McMillian Federal Com # 1 API: 30-015-22384 Eddy County, New Mexico 9/16/2016

Proposed P&A Procedure

Permanent Abandonment of Federal Wells Conditions of Approval

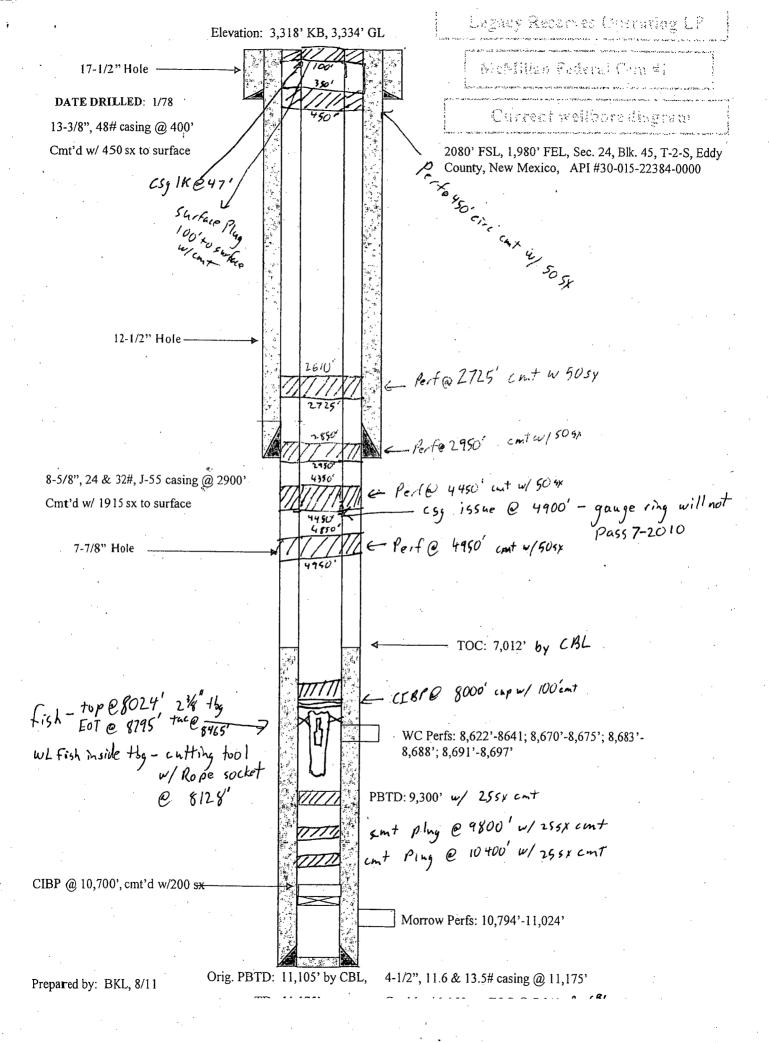
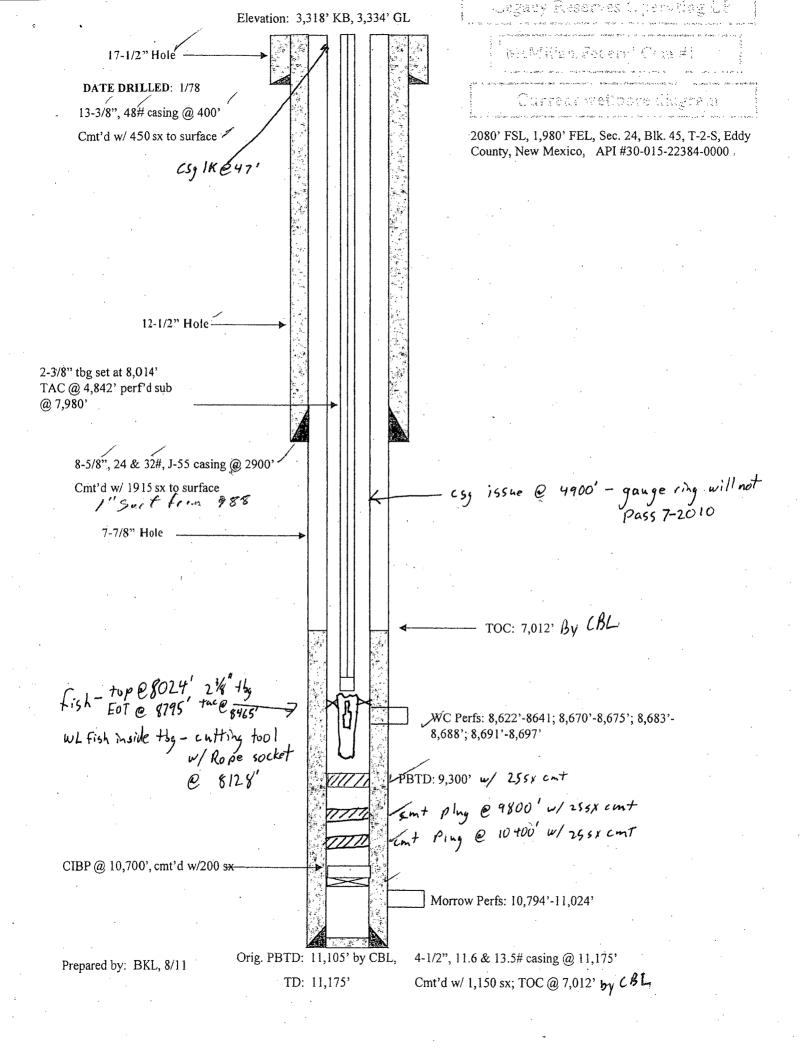
- 3. Circulate minimum 9.5 ppg P&A mud to surface.
 - 4. TOOH. Perforate at 4950'.
 - 5. RIH with PKR to 4700'. Pump into perf @ 4950' w/ minimum 50 sx cement. WOC, POOH w/packer, RIH w/ opened ended tubing and tag TOC at/above 4850'. 4800'

- 6. TOOH. Perforate at 4456. 4500 4500
 - 7. RIH with PKR to 4200'. Pump into perf @ 4450' w/ minimum 50 sx cement. WOC, POOH w/packer, RIH w/ opened ended tubing and tag TOC at/above 4350'.

- 8. TOOH. Perforate at 2950'.
 - 9. RIH with PKR to 2700'. Pump into perf @ 2950' w/ minimum 50 sx cement. WOC, POOH w/packer, RIH w/ opened ended tubing and tag TOC at/above 2850'. **ZBZD'**

* Minimum clean well to 8500' set CIBP and cap w/ 25 sx class "H" emt,

* Fert@ 800, SOZ cont to 7001 WOL Tag
